# Access Compliance Report Public Rights-of-Way (Pedestrian Signals)

Intersection ID: N/A	Main Street:	Cross Street: N/A	Location: N/A
ADA ID: B7C0AA9832F3	Signal Type: One Push Button-Non APS	Overall Compliance: No	Severity Score: BTN 1: N/A BTN 2: N/A No BTN: N/A
Codes/Mitigation Info/Possible Solution		Field Measurements/Component Compliance

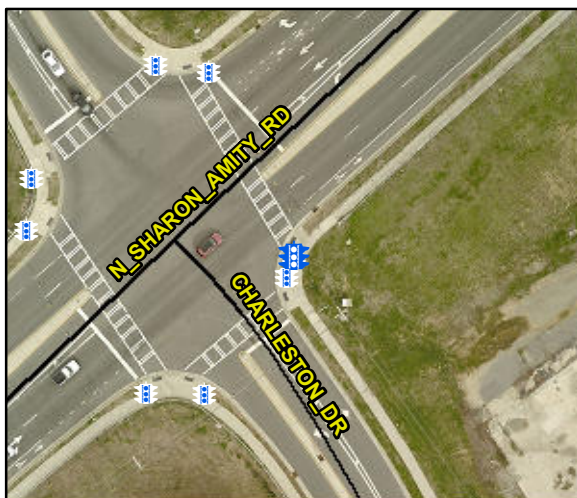
PROW/ADA: R404.2, R404.3, R406.2

N/A	B 1 FWD Approach Width (in)	N/A	N/A	B 2 FWD Approach Width (in)	N/A
N/A	B 1 FWD Approach Obstruction?	Yes	N/A	B 2 FWD Approach Obstruction?	N/A
N/A	B 1 FWD Approach Obstruction Dist (in)	2.0	N/A	B 2 FWD Approach ObstructionDist (in)	N/A
N/A	B 1 PARA Approach?	Yes	N/A	B 2 PARA Approach?	N/A
N/A	B 1 PARA Approach Constrained?	No	N/A	B 2 PARA Approach Constrained?	N/A
Yes	B 1 PARA Approach Reach (in)	3.0	N/A	B 2 PARA Approach Reach (in)	N/A
N/A	B 1 PARA Approach Width (in)	N/A	N/A	B 2 PARA Approach Width (in)	N/A
N/A	B 1 PARA Approach Obstruction?	Yes	N/A	B 2 PARA Approach Obstruction?	N/A
N/A	B 1 PARA Approach Obstruction Dist (in)	2.0	N/A	B 2 PARA Approach ObstructionDist (in)	N/A
No	B 1 Clear Floor Space Slope (%)	4.6	N/A	B 2 Clear Floor Space Slope (%)	N/A
No	B 1 Clear Floor Space XSlope (%)	3.3	N/A	B 2 Clear Floor Space XSlope (%)	N/A
N/A	B 1 PAR Slope (%)	1.7	N/A	B 2 PAR Slope (%)	N/A
Yes	B 1 Height (in)	38.0	N/A	B 2 Height (in)	N/A

Possible Solutions: Provide Push Button Extension. Remove and Replace Clear Space.
